Location:	2424 Webster Street (See map on reverse)
Assessor's Parcel Numbers:	008-0656-004-00 & -001-00
Proposal:	Design Review discussion for a proposed development that would include an 11-story commercial building containing approximately 162,000 square feet of office space and approximately 9,500 square feet of ground floor retail.
Applicant:	Elisse Douglass/ Signature Development Group
Owners:	2410 Webster Investors LLC
Planning Permits Required:	Regular Design Review for new construction, Major Conditional Use Permit for D-BV-1 height bonus and to extend building height into adjacent zone.
General Plan:	Central Business District
Zoning:	D-BV-1 (BVDSP Retail Priority Site 3C) D-BV-2
Environmental Determination:	Determination Pending
Historic Status:	2428 Webster Street – OCHS Rating: Ec3 2406 Webster Street – OCHS Rating: C3
City Council District:	3
For further information:	Contact case planner Pete Vollmann at (510) 238-6167 or by email: pvollmann@oaklandca.gov .

SUMMARY

CITY OF OAKLAND PLANNING COMMISSION

Case File: PLN19148
Applicant: Elisse Douglass/ Signature Development Group
Address: 2424 Webster Street
Zone: D-BV-1 (BVDSP Retail Priority Site 3C), D-BV-2
Height Area

EXTERIOR ELEVATION: EAST
04/10/20

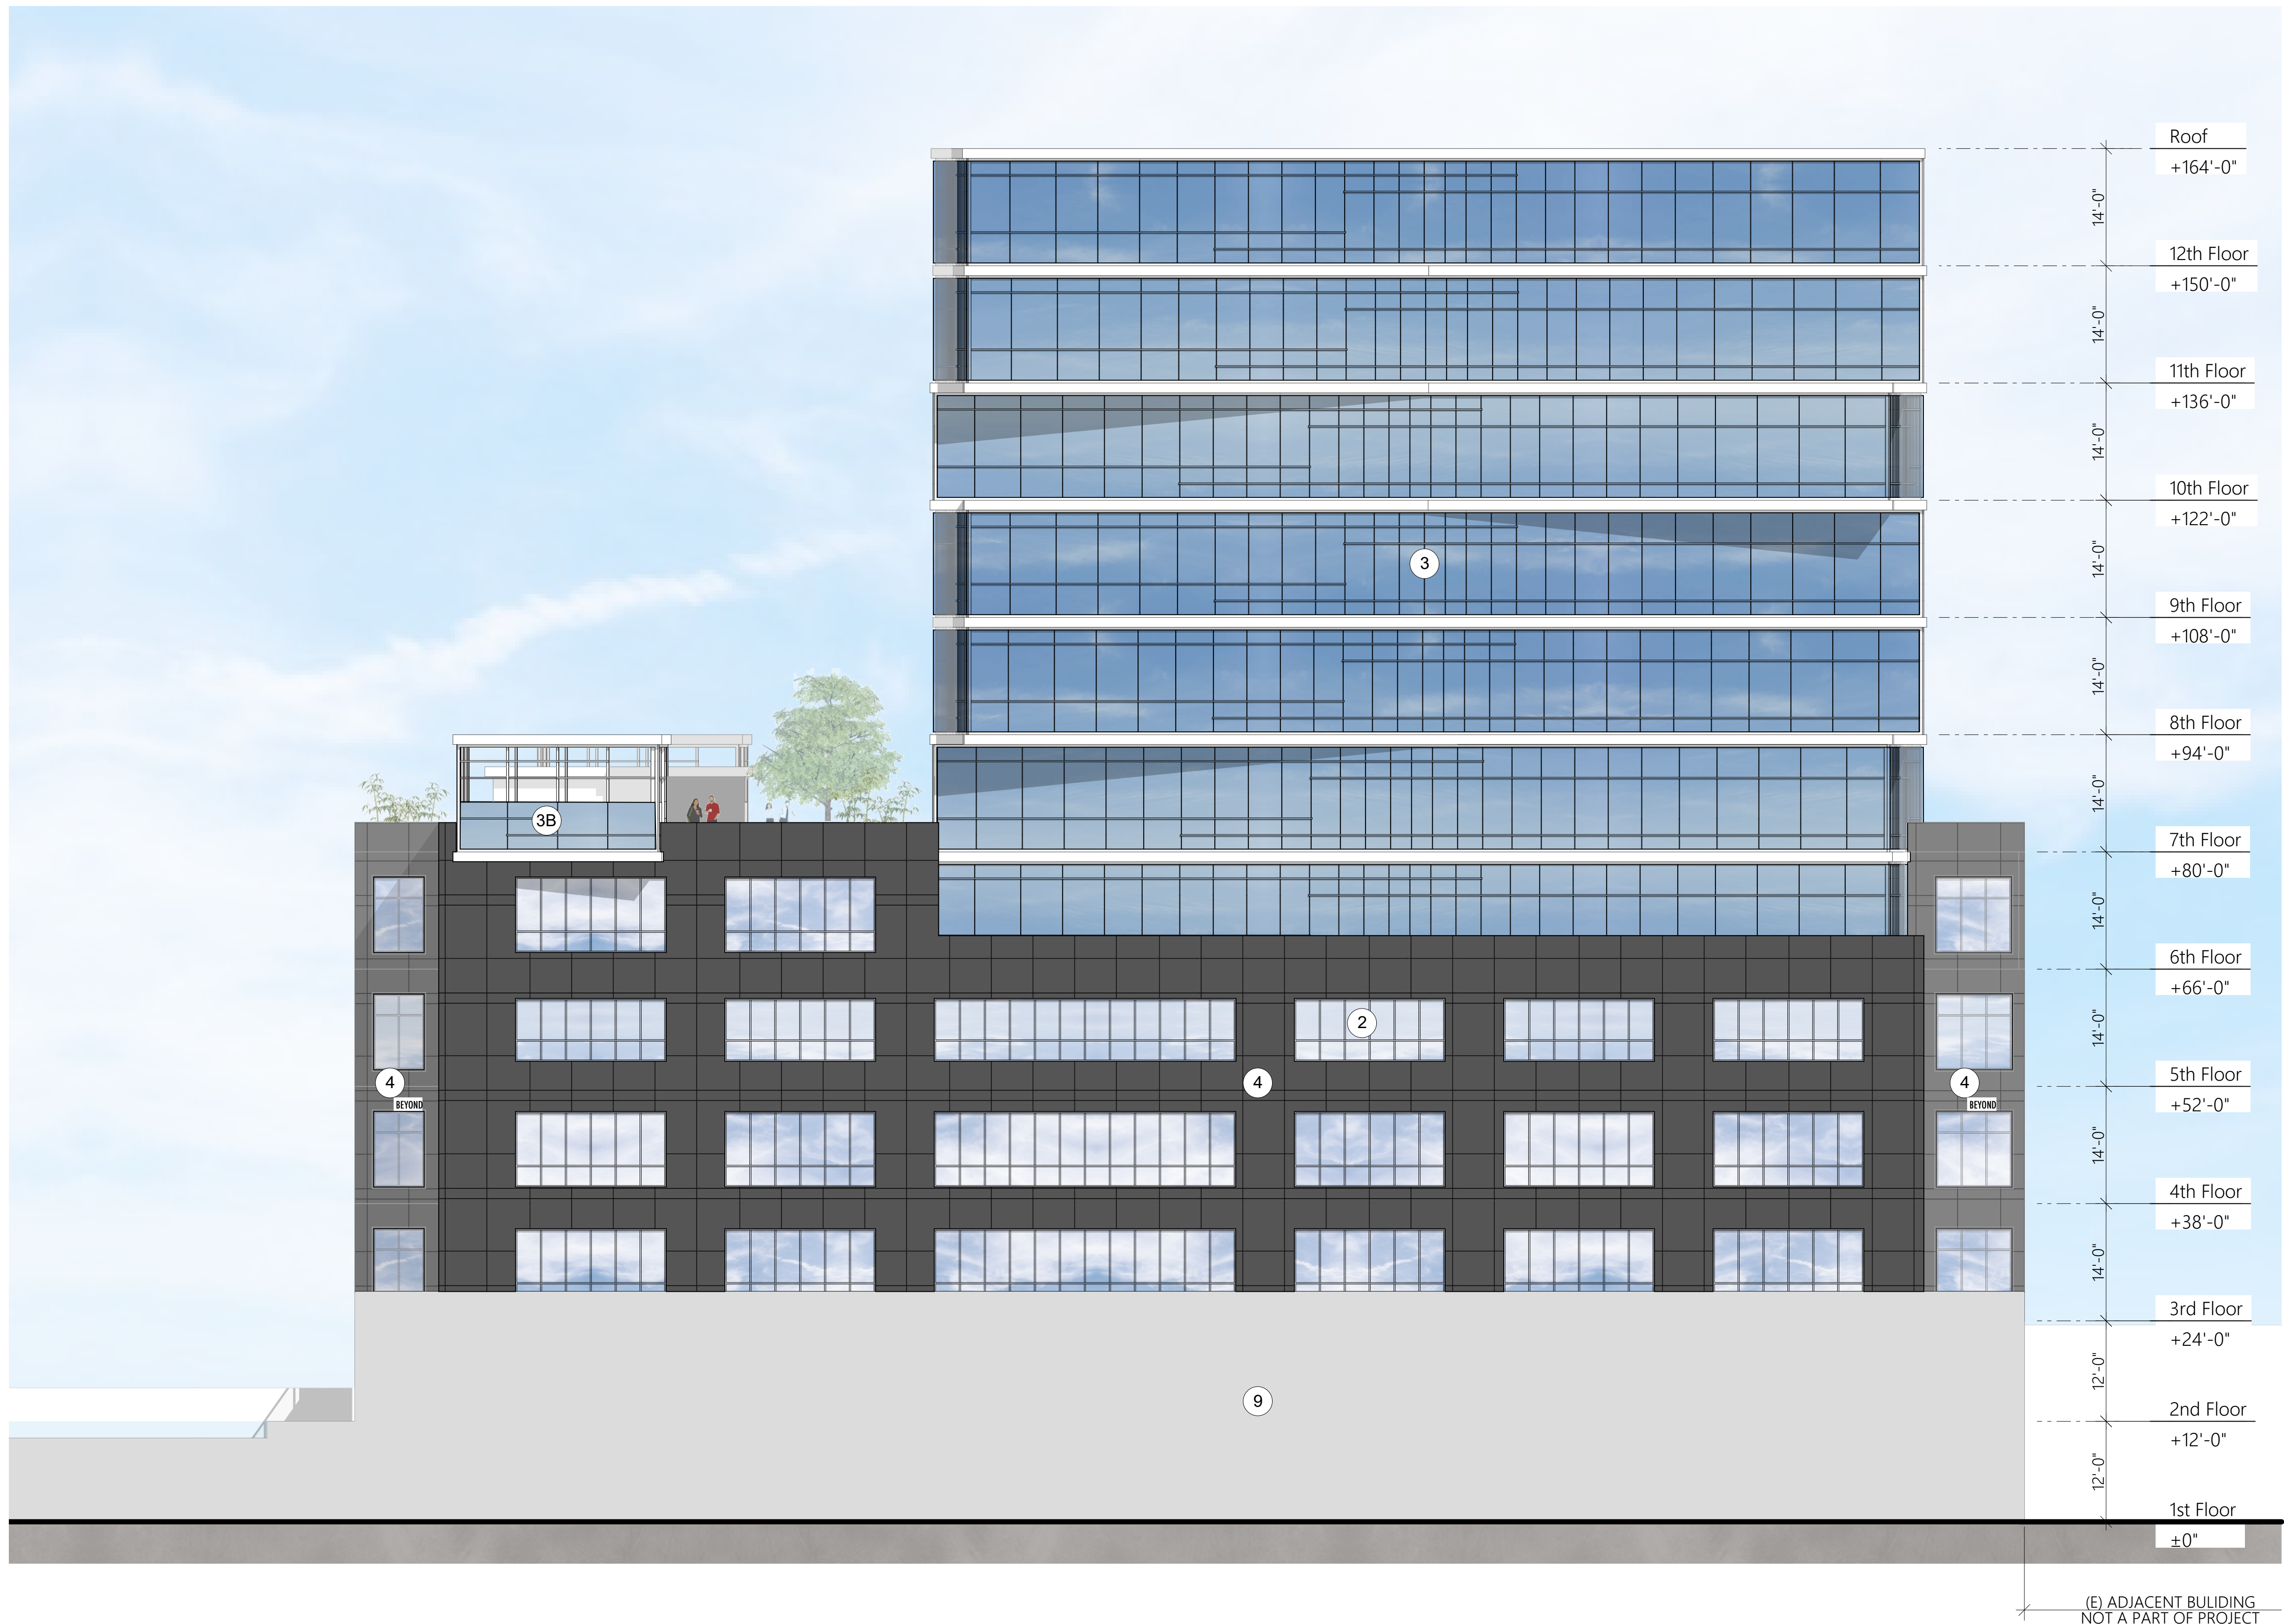
Staff feels that the ground floor of the proposal fits in well with the surrounding area with both the older Auto Row Showrooms as well as the new mixed use buildings in the area that have been developed since the adoption of the Broadway Valdez Specific Plan. The portion of the building that projects up to five stories also complements the area with the window pattern and exterior materials. Staff does have concerns about the rooftop projection from the roof deck that extends out from the façade toward Webster Street as it has the feeling of being top heavy and tacked on to the building.
